2nd Further Information

**Proposed Temporary Place of Recreation, Sports or Culture (Hobby Farm) with Ancillary Eating Place and Associated Filling of Land for a Period of 5 Years in "Agriculture" ("AGR") Zone and Area shown as 'Road',
Various Lots in D.D. 17 and Adjoining Government Land, Ting Kok, Tai Po, New Territories**

(S.16 Planning Application No. A/NE-TK/843)

Response-to-Comment (RtC)

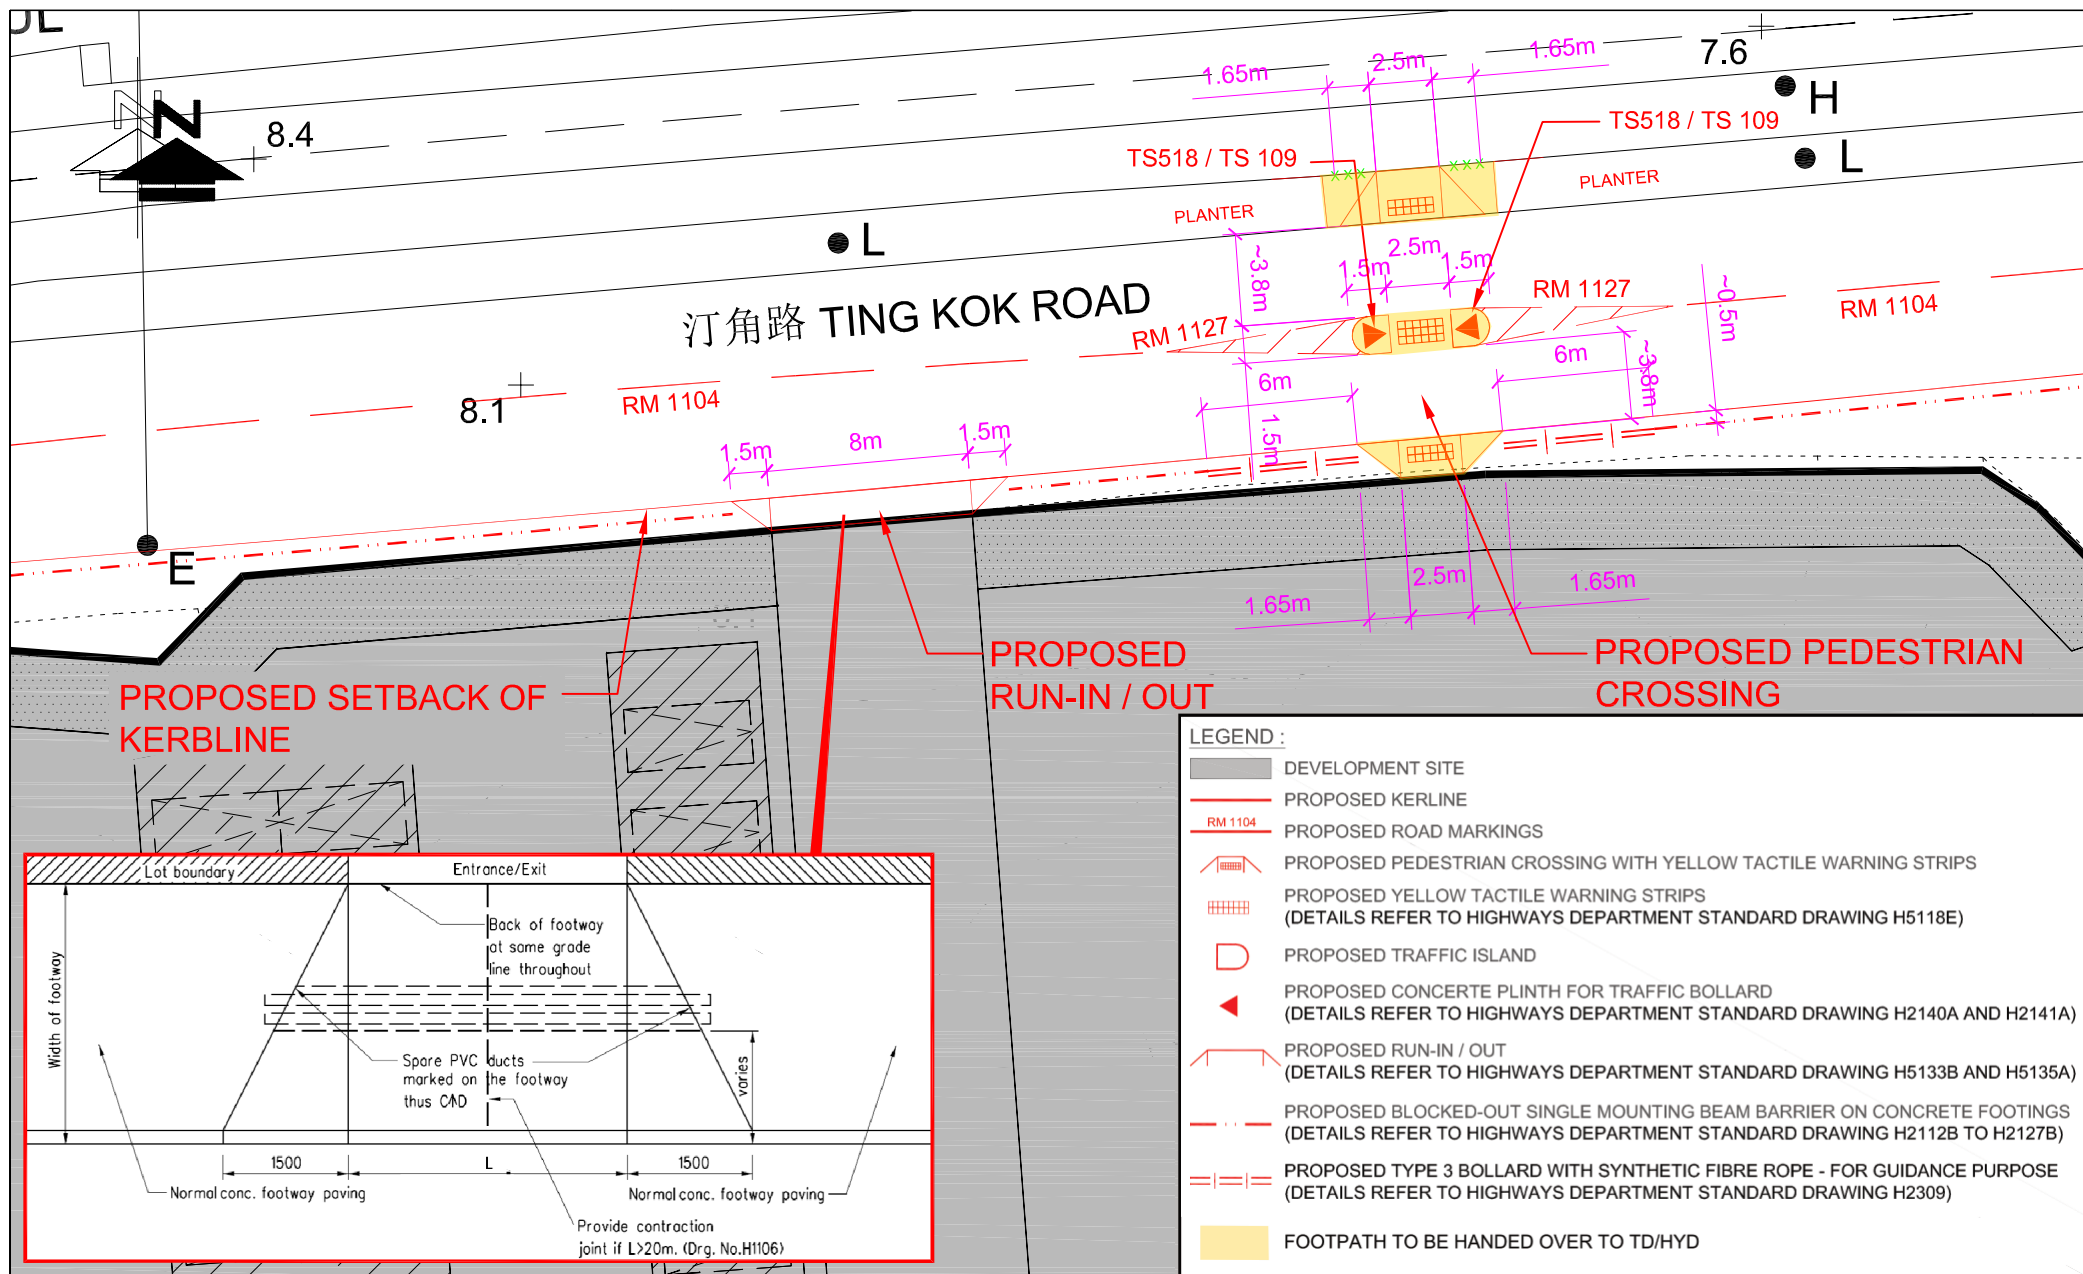
(b)	With reference to our records, there is no existing footpath being maintained by HyD in connection to the application site. The applicant should further clarify the extent of the proposed footpath to be formed by the applicant and to be handed over to TD/HyD.	Referring to the run-in/out and pedestrian proposal submitted under previous planning application No. A/NE-TK/678 as attached at Annex 1 , the extent of the proposed footpath is highlighted for clarification.

(b)	With reference to our records, there is no existing footpath being managed by TD in connection to the application site. The applicant should further clarify the extent of the proposed footpath to be formed by the applicant and to be handed over to TD/HyD.	By referring to the run-in/out and pedestrian proposal submitted under previous planning application No. A/NE-TK/678 as attached in Appendix A, the extent of the proposed footpath is highlighted for clarification.

Project No. 83075	Rev.
Dwg No. Figure 1	A

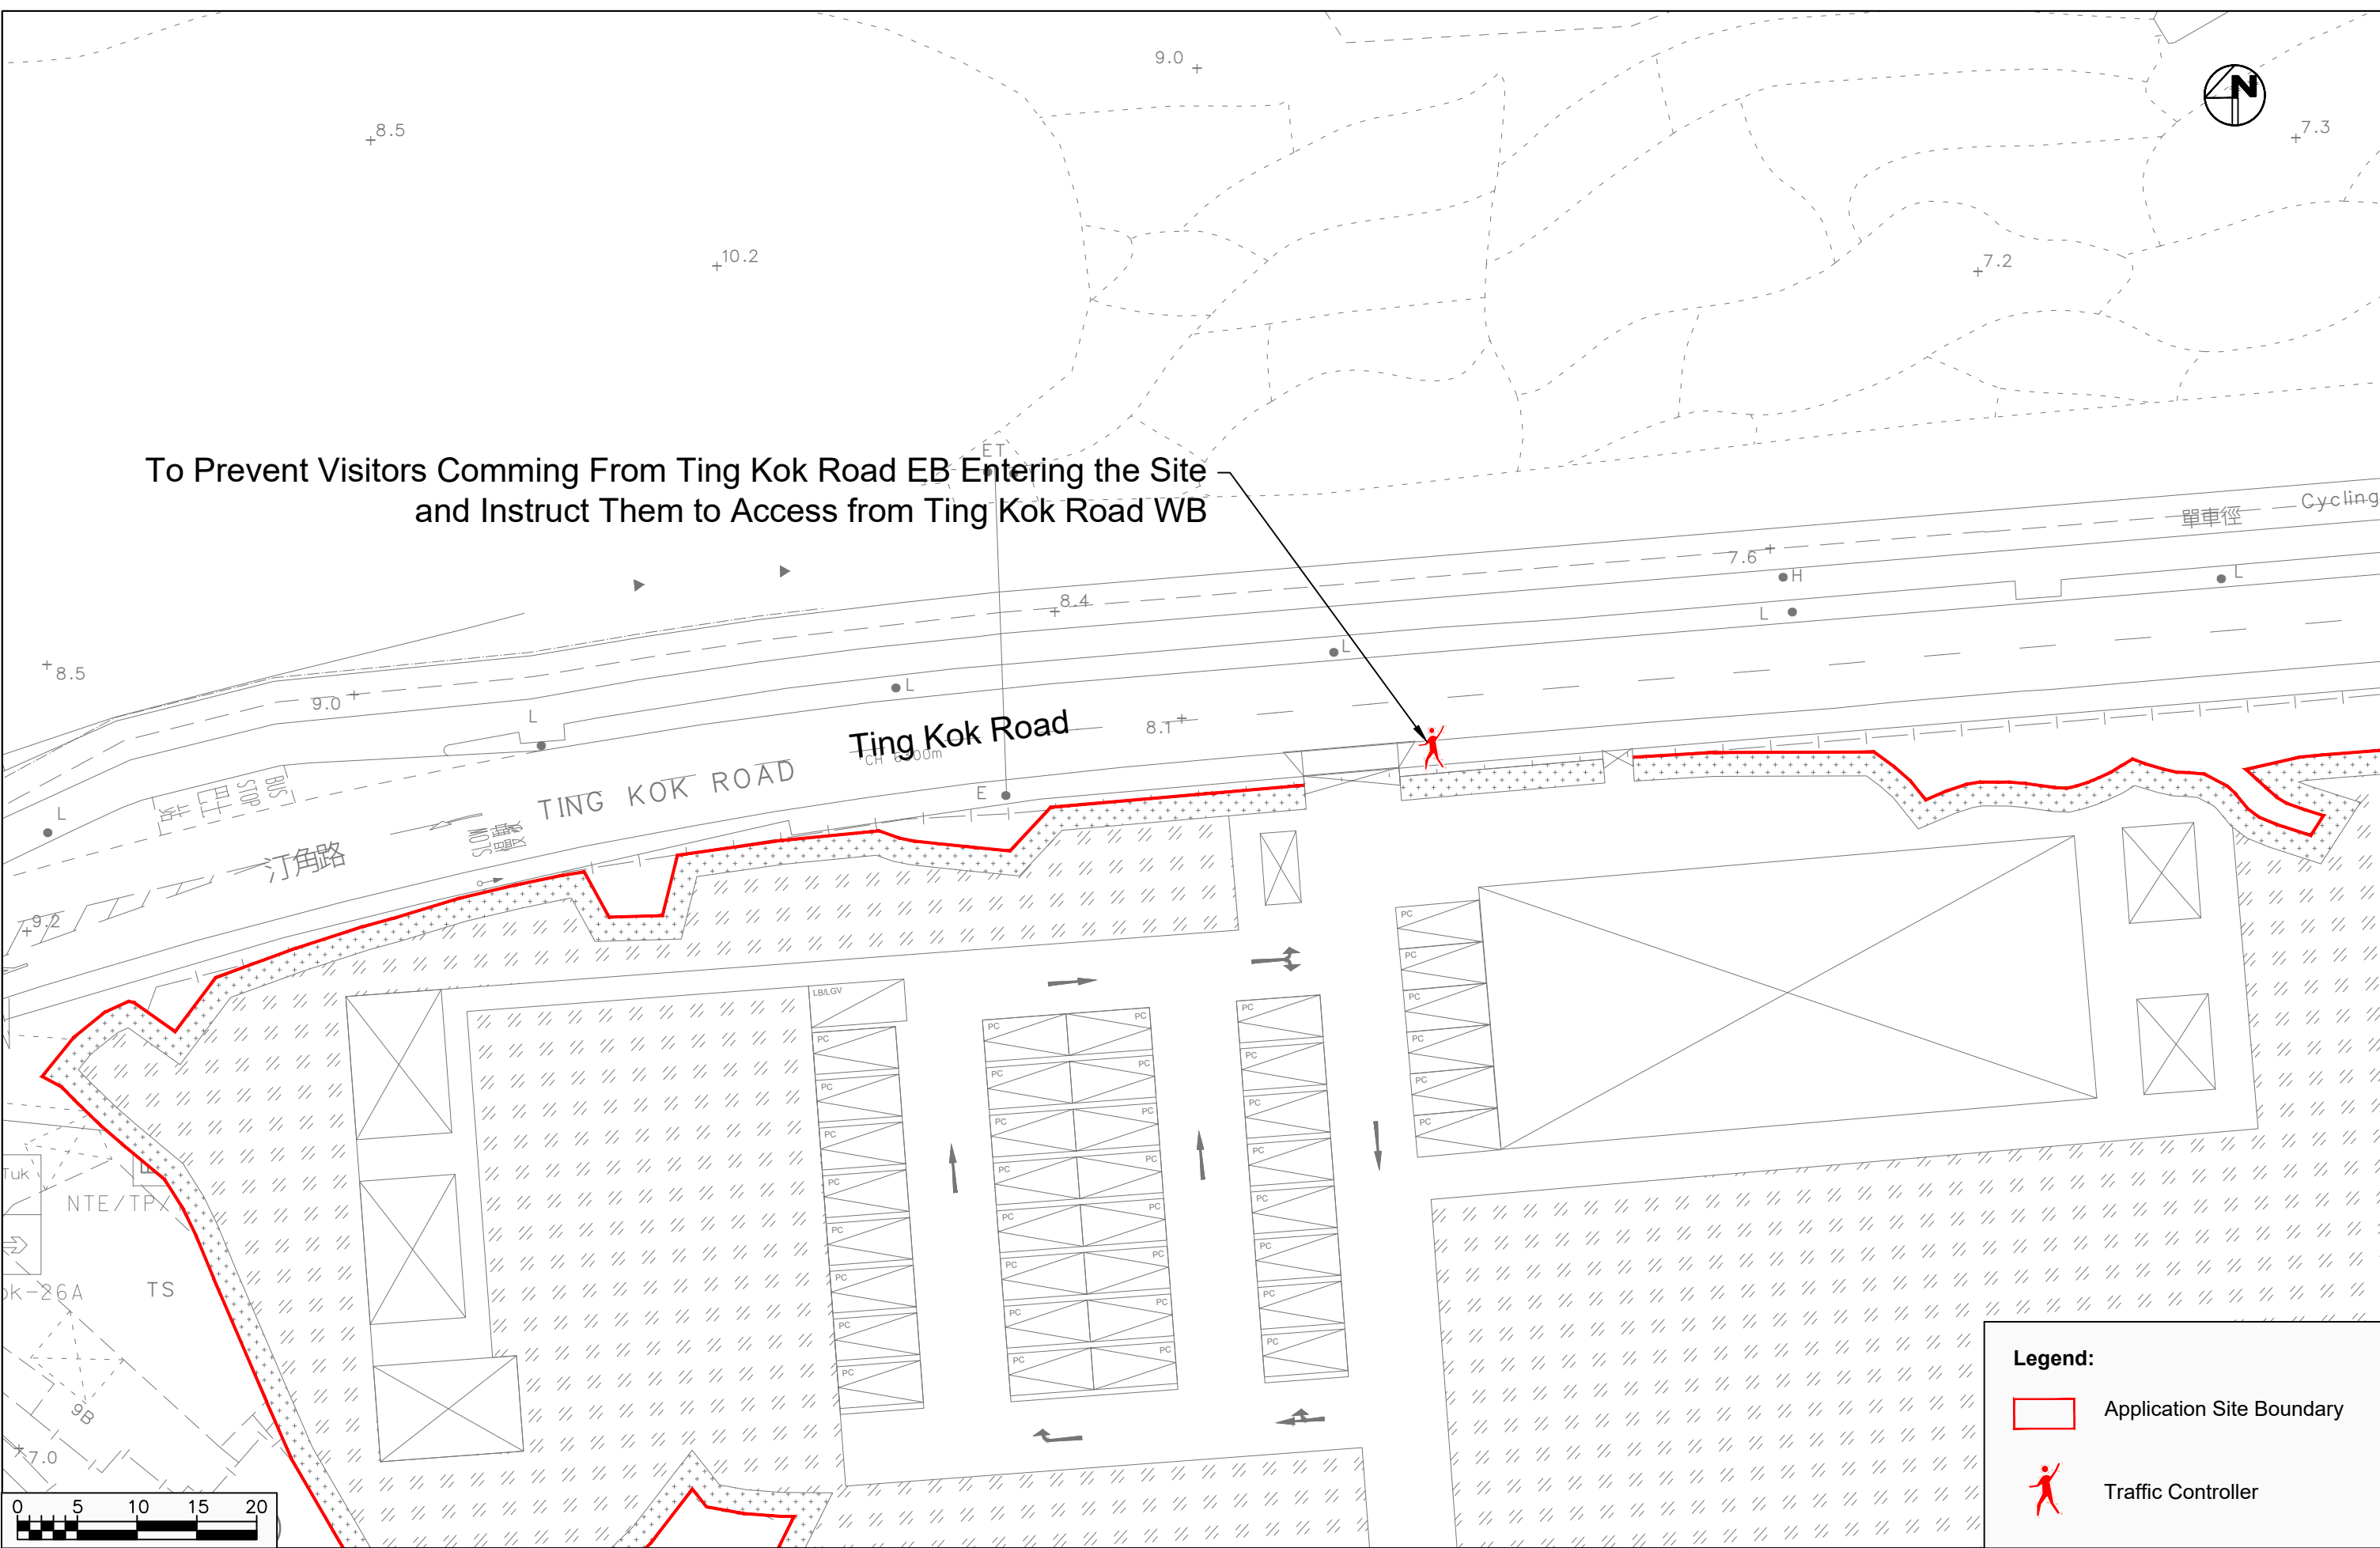
3. Comments of the Commissioner for Transport (C for T)		
(a)	The applicant shall implement appropriate management measures preventing their guests queuing on public road near the site entrance, rather than erecting "No Right Turn" traffic signs. The enforcement measures shall be the last resort when all management measures carried out by the applicant are ineffective.	Rather than erecting "No Right Turn" traffic sign, management plan will be implemented by the applicant (refers to Figure 1) to deploy a traffic controller at the access of the application site (the Site) to instruct visitors coming from Ting Kok Road eastbound to take the specified route to enter the Site from Tin Kok Road WB, preventing them to queue on the public road. The accessing route from Ting Kok Road eastbound to the site (refers to Figure 2) will be informed to the visitors upon reservation.

To Prevent Visitors Comming From Ting Kok Road EB Entering the Site and Instruct Them to Access from Ting Kok Road WB
